Notice for field support to effect of the earthquake in Eastern Japan on products

As of September 15th,2011
OP Support Dept., KMBT CS Headquarters

Due to effects from the earthquake taken place at Japan on March 11, part of electronic components (microprocessors) are in current use cannot be procured and our production will be performed using microprocessors with different model codes. This measure produces an effect on FW compatibility that requires attention during field support activities.

No. 1) Change in model of microprocessor (IC400:H8S) to one with a different model code mounted on MFP board

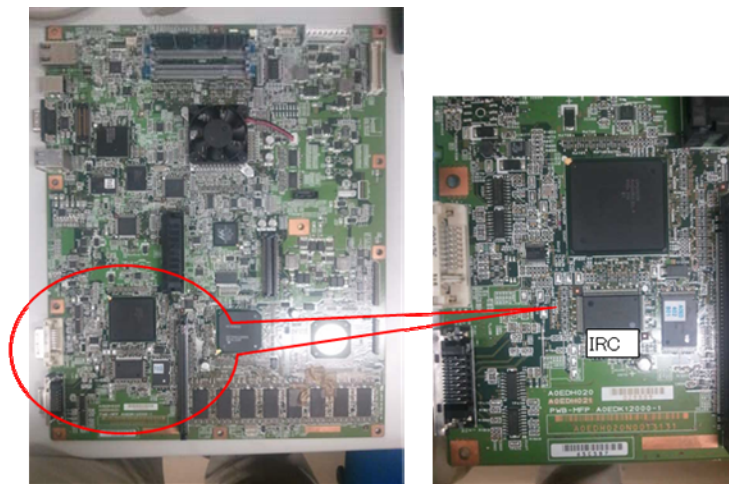
HD6412324SVF25V [H8S/2324] → R4F24248NVFPV/R4F24249DVFPV [H8S/2424] (Amur 1/2/3)

HD6412324SVF25V [H8S/2324] → D13006DF13V [H8S/3006] (Taiga 0/1)

HD6412324SVF25V [H8S/2324] → R4F24255NVFPU [H8S/2425] and R4F24248 [H8S/2424] (Taiga 2/3)

No. 2) Change in model of microprocessor (IC1:H8S) to one with a different model code mounted on FS-526 FNS control board

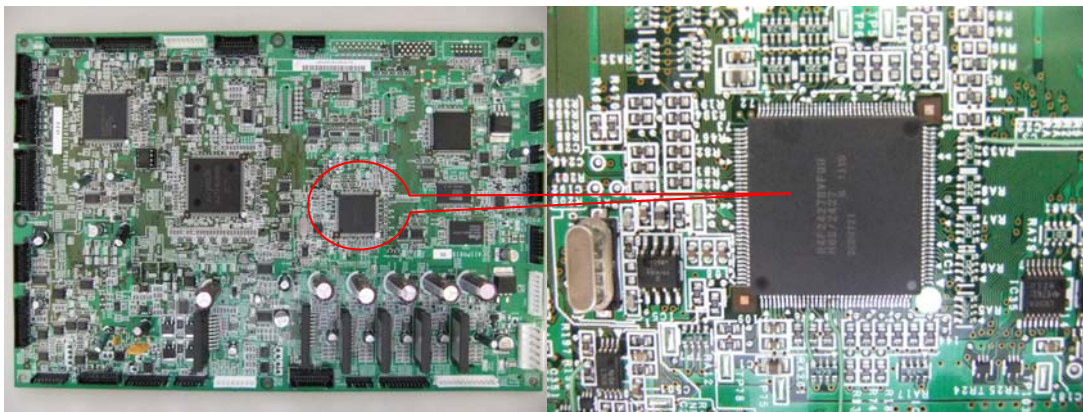
Components to be changed: HD64F2378BVFQ35V [H8S/2378] → To R4F24278 [H8S/2427] or R4F24269 [H8S/2426]

7) How to identify the MFP board with substitute microprocessor mounted:
<Boards> Model codes for boards will be changed as follows.

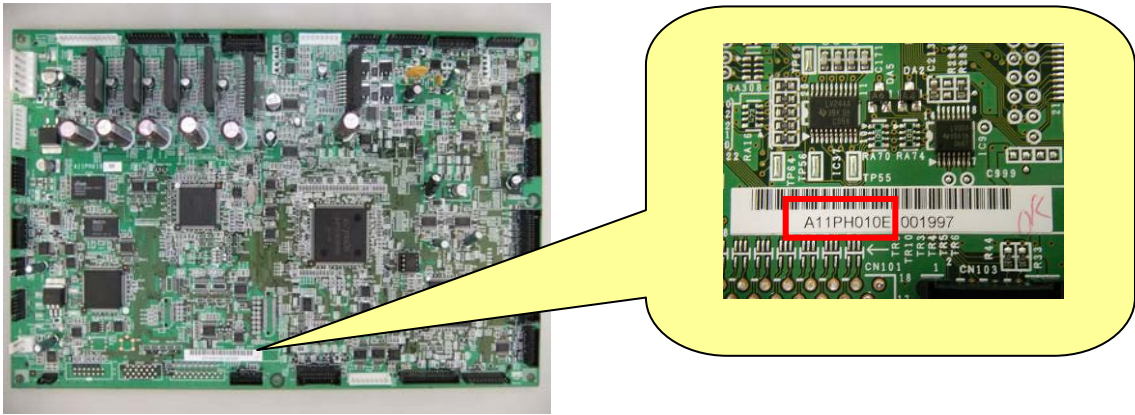
CPU model code	Board number
H8S/2427	A11PH810E
H8S/2426	A11PH811E

7) How to identify the modified component:

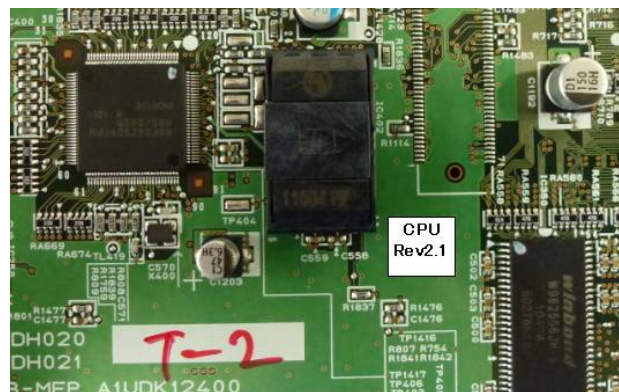
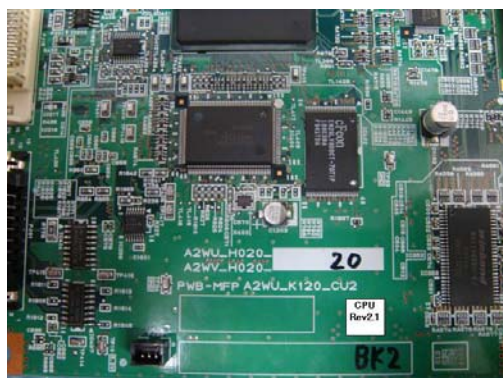
The board mounted with the CPU Rev. 2.1 will be marked with the identification of "CPU Rev. 2.1" as shown below.
(The board number is not to be changed in conjunction with the current revision up of the microprocessor.)
